## NORTHERN BEACHES LOCAL PLANNING PANEL

ITEM 4.1	PEX2022/0001 - 10-12 BOONDAH ROAD, WARRIEWOOD - PLANNING PROPOSAL
AUTHORISING MANAGER	MANAGER, STRATEGIC & PLACE PLANNING
TRIM FILE REF	2022/496912
ATTACHMENTS	1 <a href="#">NSW State Emergency Service (SES) Preliminary Advice</a> 2 <a href="#">Submissions - Summary of Issues Raised</a>

To report the assessment of a Planning Proposal for land at 10-12 Boondah Road, Warriewood and to recommend that the Panel advise Council to reject and not progress the Planning Proposal to a Gateway Determination.

Figure 2 - Flood Hazard Map

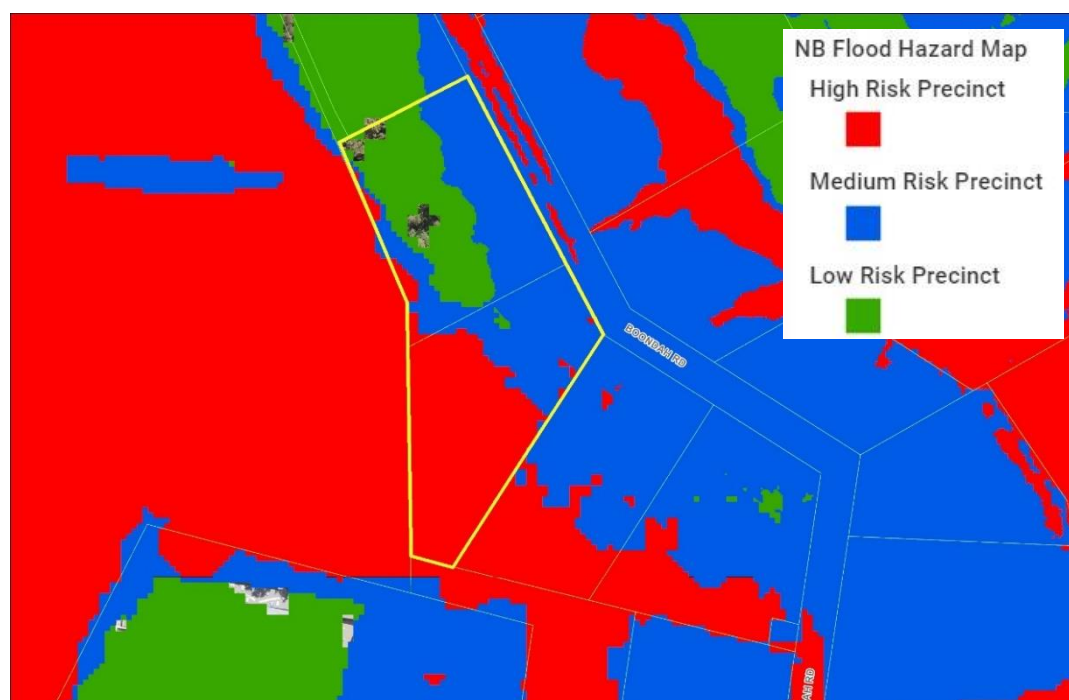
The site is in the Flood Planning Area. Council's Flood Hazard Map identifies High, Medium and Low Risk Precinct areas within the site (see Figure 2).

The Pittwater Development Control Plan (DCP) includes flood-related controls in section B3.11 Flood Prone Land. For land affected by flooding in High and Medium Risk Flood Precincts, the controls require that development must demonstrate, amongst other things, for all flood events up to the 1% AEP event: no adverse impacts on flood levels or velocities caused by alterations to the flood conveyance, no adverse impacts on surrounding properties, and no net loss of flood storage.

The Planning Proposal involves filling of most of the proposed R3 zoned land and the magnitude of filling is significant to meet required flood planning levels for the townhouses of RL4.4m, well above existing ground levels of around 2-4m AHD. Without adequate compensatory cut, this will result in a sizeable net loss of flood storage from the site which will need to be absorbed by other properties in the floodplain. The proponent has not demonstrated no net loss of flood storage. No volumetric calculations showing the proposed cut and fill balance have been provided. The proponent has instead focused on modelling to demonstrate no adverse impacts on surrounding properties and compliance with specific DCP controls for Warriewood Valley Release Area under C6.1.

Figure 8 – Proposed Zoning

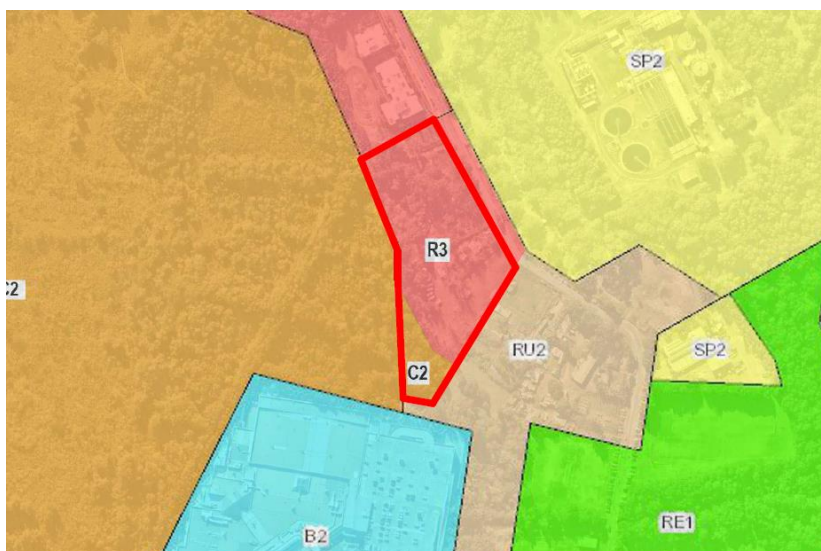
- while the applicant has stated that the proposed C2 zoning boundary encompasses all of the mapped Coastal Wetland under State Environmental Planning Policy (Resilience and Hazards) 2021, the proposal appears to include roads, earthworks, asset protection zones, bioretention basins, and stormwater filters and discharge points within the mapped Coastal Wetland areas;

- while the applicant has stated that the proposed C2 zoned land is intended to remain in private ownership under a Community Title scheme, without legal advice to indicate otherwise, there is a possibility that the C2 zoning could trigger an obligation for Council to acquire the land under the owner-initiated hardship provisions of the Land Acquisition (Just Terms Compensation) Act 1991, if the C2 zoning is deemed to be reserving the land for use for a public purpose. Despite enquiries made by Council planners, the NSW Department of Planning and Environment was unable to clarify the operation of the relevant legislation in this instance due to legal complexity;
